RECEIVE AND FILE COMMUNICATION FROM THE PLAN AND ZONING COMMISSION REGARDING APPROVAL OF PRELIMINARY PLAT AMENDMENT TO THE “WOODS ON THE RIVER PLAT 11” PLAT FOR PROPERTY LOCATED IN THE VICINITY OF RIVERWOODS ROAD AND RIVER RIDGE AVENUE

Communication from the City Plan and Zoning Commission advising that at their August 5, 2021 meeting, the following action was taken regarding a request from Hubbell Realty Company (owner) represented by Steve Mosely (officer) (officer) for review and approval of a major Preliminary Plat Amendment to “Woods on the River Plat 11” for property in the vicinity of Riverwoods Road and River Ridge Avenue, to allow the subdivision of existing platted Outlots for a total of 22 single-family residential lots.

Hubbell Realty Company, Woods on the River Plat 11, Vic. Riverwoods Road & River Ridge Ave. 13-2021-1.45

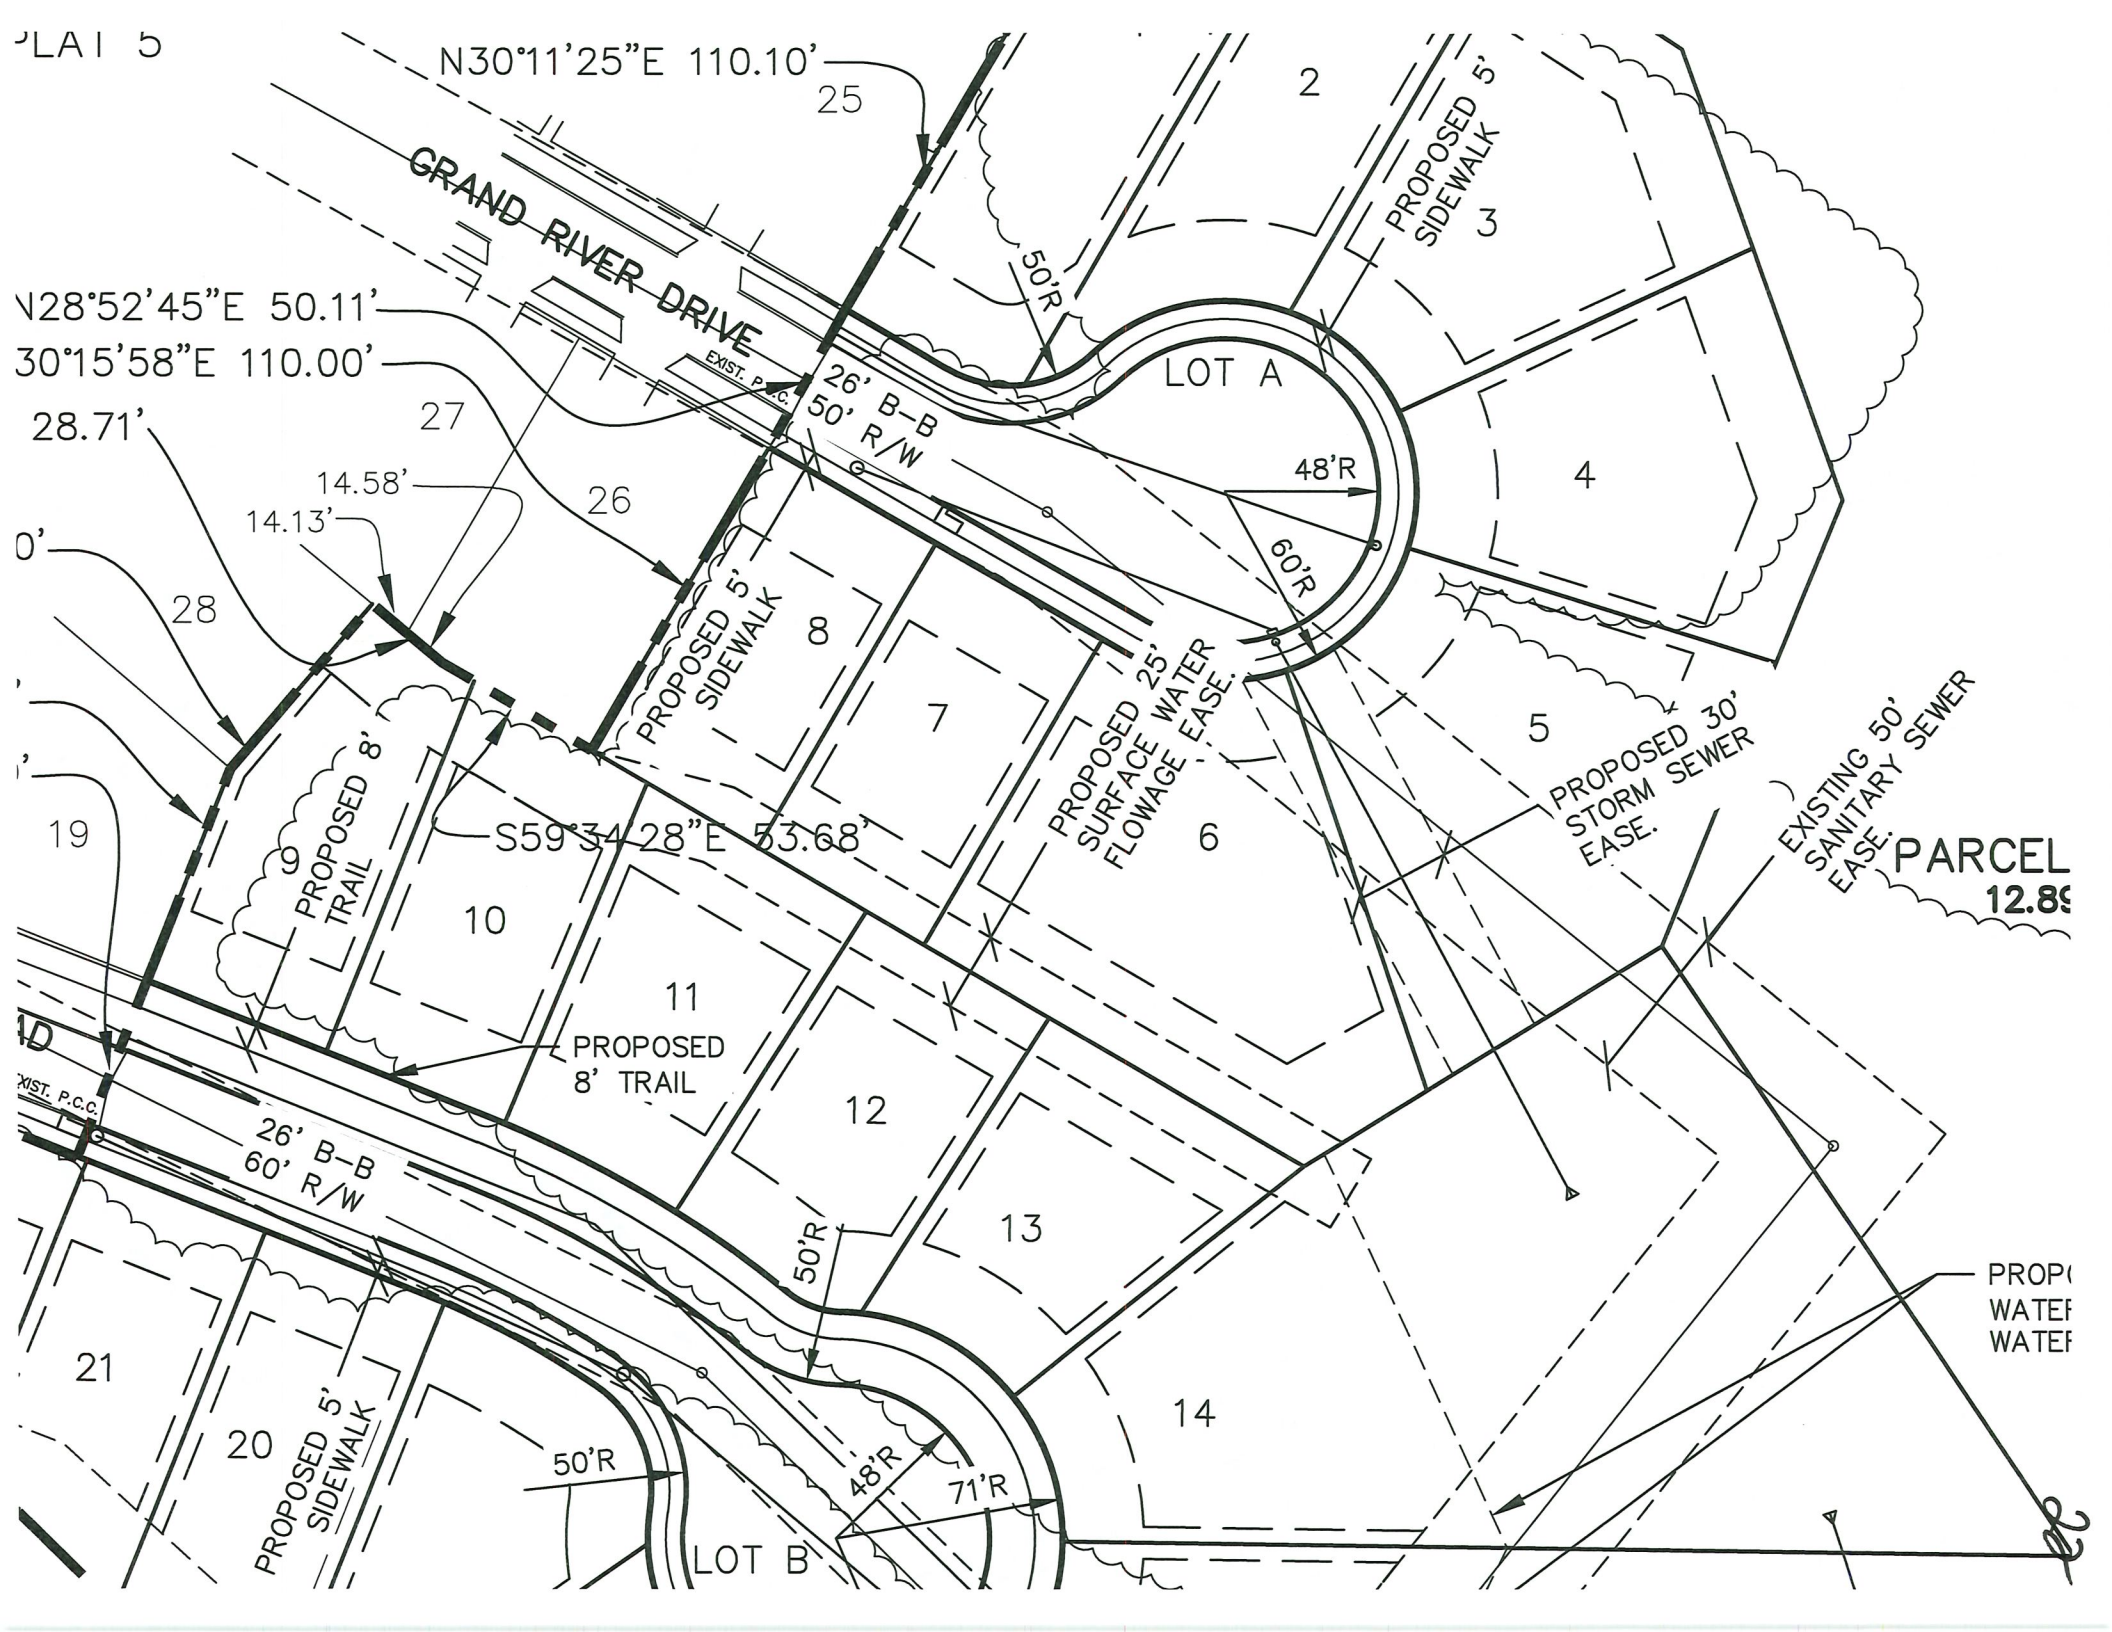
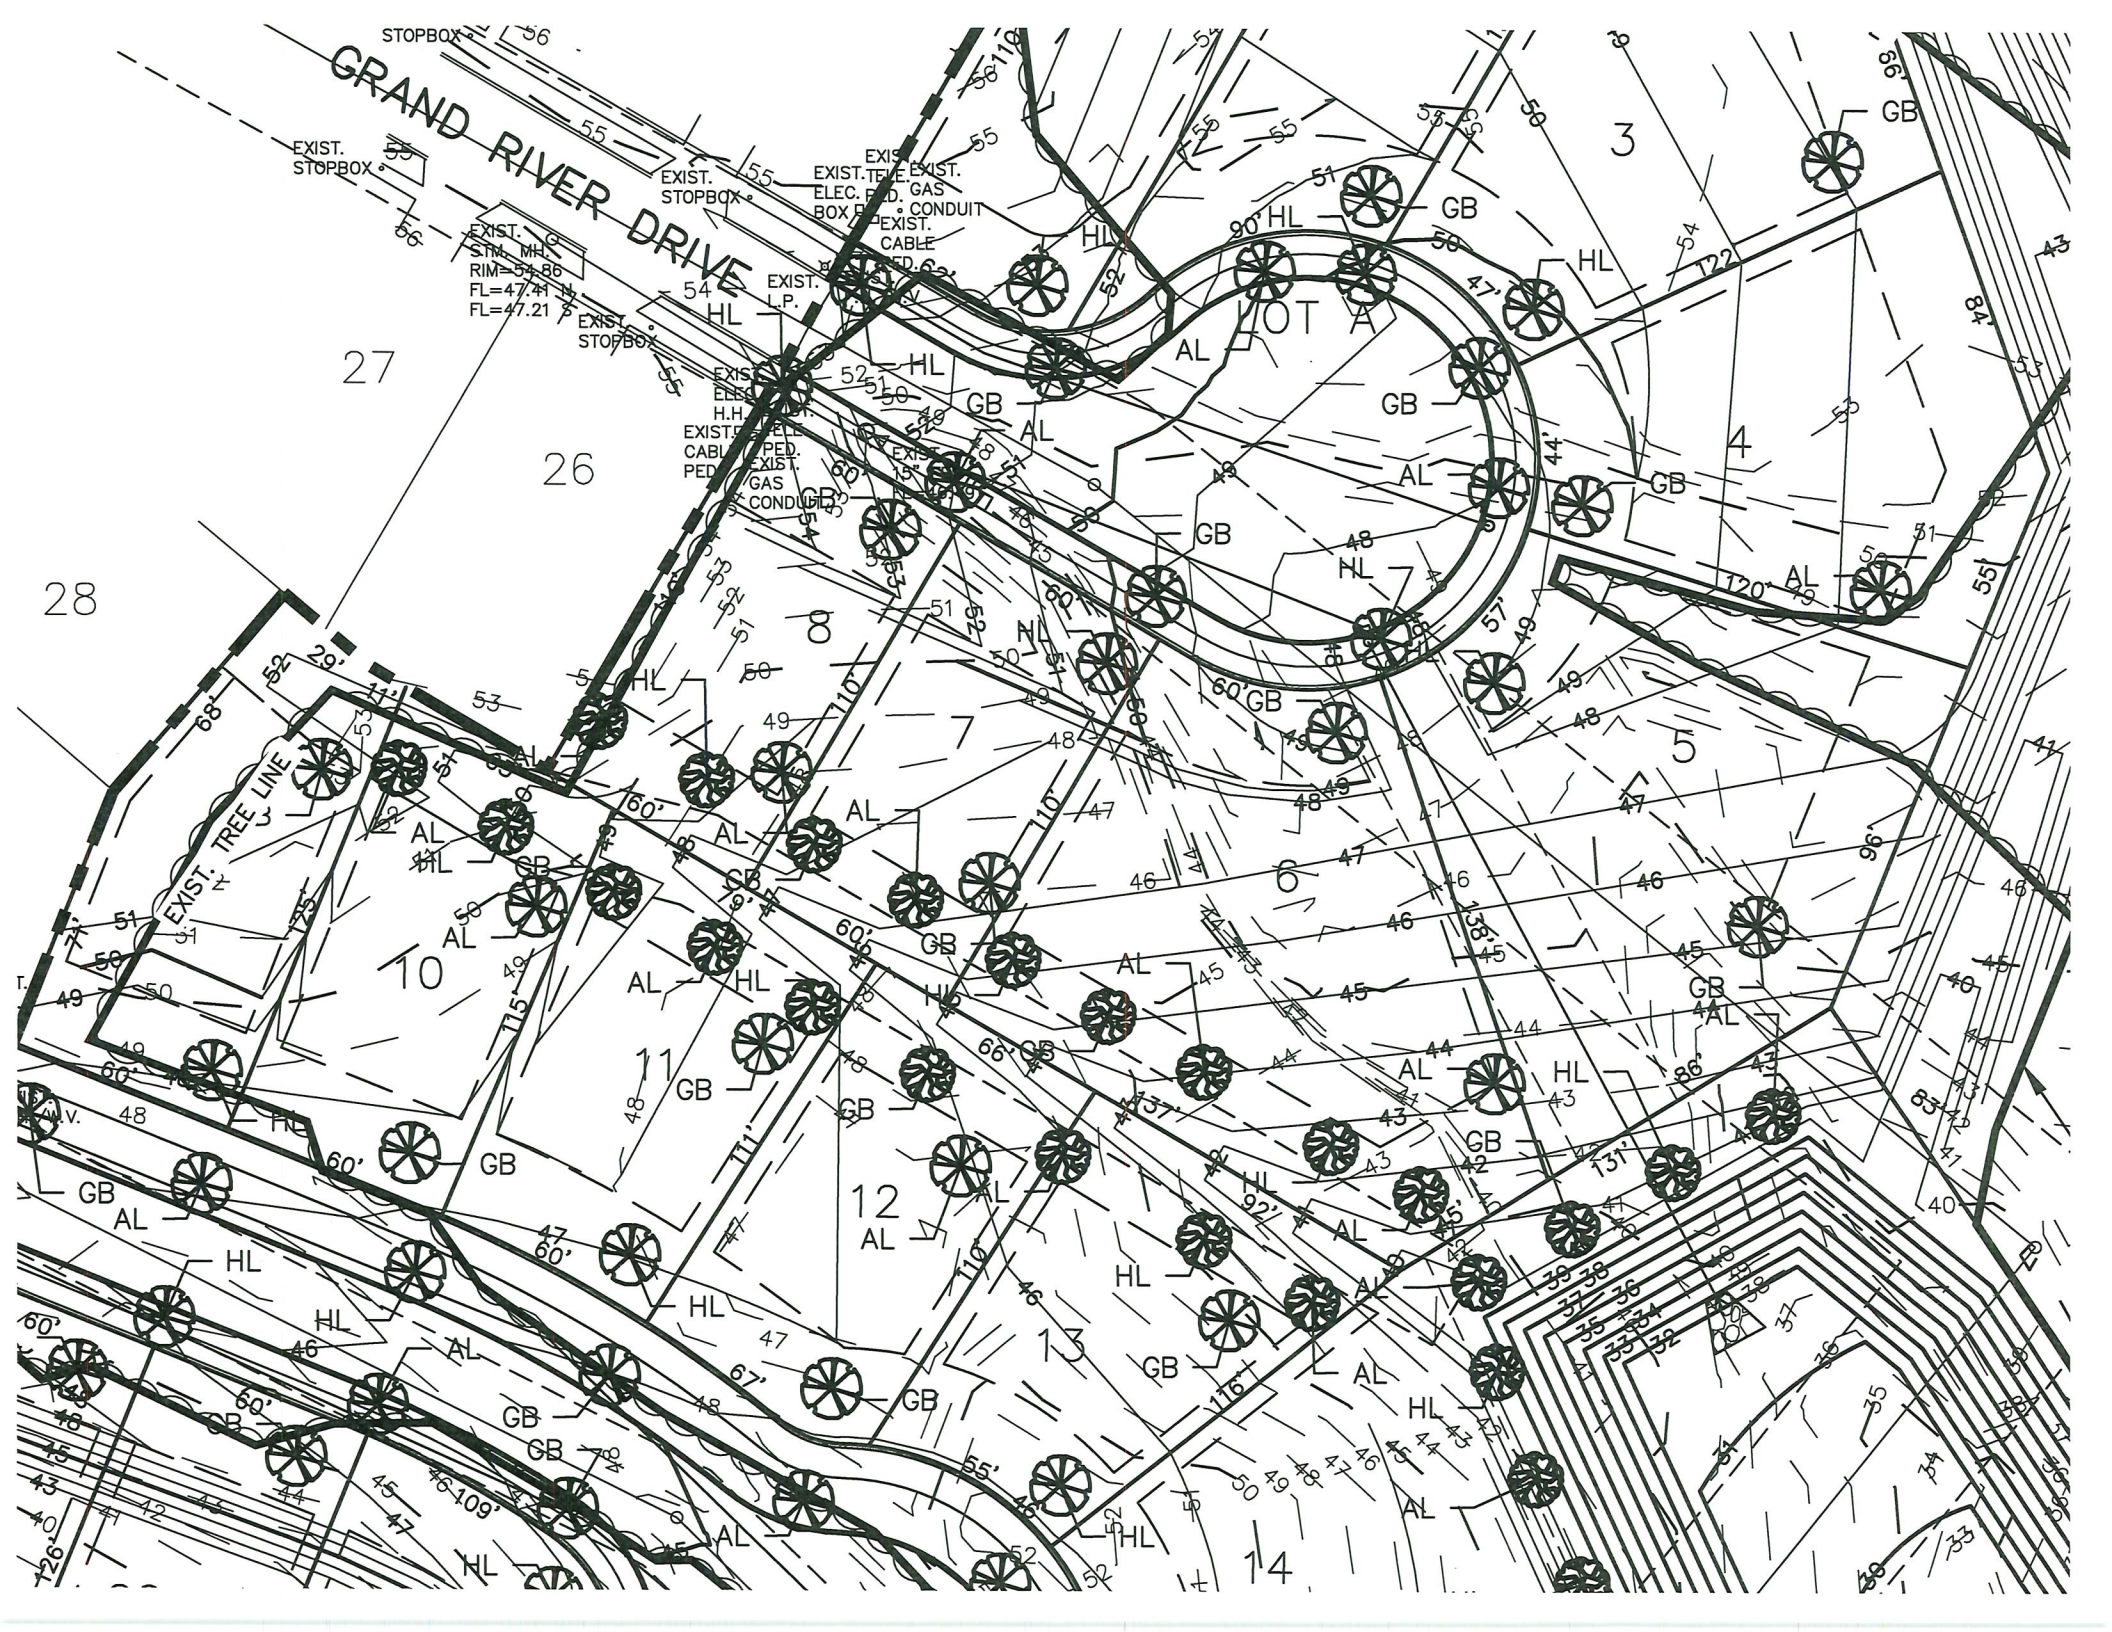
2. Natural Features: A significant portion of the subject property is heavily wooded. Staff recommends provision of a note that states development of the site must comply with the Tree Removal and Mitigation Ordinance contained in Chapter 42, Article X, of the City Code.

The proposed Preliminary Plat demonstrates that excess land at the periphery of the proposed lots for one-household development would be contained in an outlot that could potentially be dedicated to the City as parkland. Staff recommends provision of a note to state that any and all portions of this area that the City is not willing to accept ownership for shall be designated as common areas shared by the owners of all the residential units. Common areas within a horizontal property regime are not separately taxed. In a horizontal property regime, the value of the common areas is allocated among the residential units.

3. Drainage: The proposed Preliminary Plat demonstrates a stormwater detention basin within an outlot at the eastern periphery of the site. The City will require the entire future plat to be located within a horizontal property regime, with the detention basin designated as common area shared by the owners of all the residential units. Common areas within a horizontal property regime are not separately taxed. In a horizontal property regime, the value of the common areas is allocated among the residential units.

Given the proximity of the proposed stormwater basin to the existing Carl Voss Recreation Trail, staff recommends provision of a note that states any stormwater basin shall be designed to the satisfaction of the both the City's Engineering Department and the City's Park & Recreation Department to ensure that it is designed in a manner that prevents future erosion issues that could potentially impact the recreational trail.

The Preliminary Plat must also include a note that states that a soils report and stormwater runoff control plan per City Code Section 106-136 is required and that all grading is subject to an approved grading permit and soil erosion control plan.

4. Utilities: There are sanitary sewer and water mains nearby that will be extended to serve the development. These mains are shown within the proposed public street network. Construction of these mains will extend to the end of the Grand River Drive and River Ridge Road cul-de-sacs.

5. Traffic/Street System: The proposed amendment to the Preliminary Plat would revise the configuration of the one-household residential lots and eliminate the extension of River Ridge Road to East Park Avenue and reduce the length of the Grand River Drive

cul-de-sac. Staff believes that these revisions are appropriate and would preserve a significant area of existing mature tree canopy. Planning staff also believes that the existing Riverwoods Avenue can accommodate the north/south traffic through the existing "Riverwoods" development to East Park Avenue.

6. **Recreational Trail:** There is a 10-foot-wide recreational trail (known as the Carl Voss Trail) that passes through the eastern portion of the Preliminary Plat, as well as a trail spur that provides access to the trail from River Ridge Road. The recently approved amendment to the PUD Conceptual Plan contains multiple conditions pertaining to these trails, which must be provided as notes on the Preliminary Plat.
7. **Urban Design:** The proposed Preliminary Plat would allow for a total of 22 additional lots, each at least 60 feet wide, for one-household development. The Conceptual Plan provides eight (8) character examples of front facades of homes that would be constructed. Staff has recommended the notes listed below be added to the preliminary plat to ensure development complies with the PUD Conceptual Plan.

Walt Anderson 2605 Bent Ridge Court asked if Hubbell Realty or the homeowners association (HOA) will be liable for maintaining the proposed detention basin? According to the site plan, he believes there might be plans for another detention pond further up the road and they need to find a better way to compress the new lot sizes.

Abby Chungath stated there might be a little confusion around whether this is a standing water pond or a dry area that's used to absorb storm water.

Chris Draper asked if the cost will be spread out to the current houses or contained within the new lots.

Bert Drost stated the PUD requires a minimum lot width of 60-feet which the new lots would be. The storm water basin would be maintained by a HOA formed by the new development.

Bert Drost stated this would be a dry area used to absorb the water.

Doug Saltgaver stated there would only be 1 storm water basin, which would be a dry bottom basin. The HOA will be liable for maintaining the basin, which would include the lots constructed in plat 10 and 11.

Dough Saltgaver stated it would include lots in plat 10 and 11. Plats 1-9 will not be assessed for these basins.
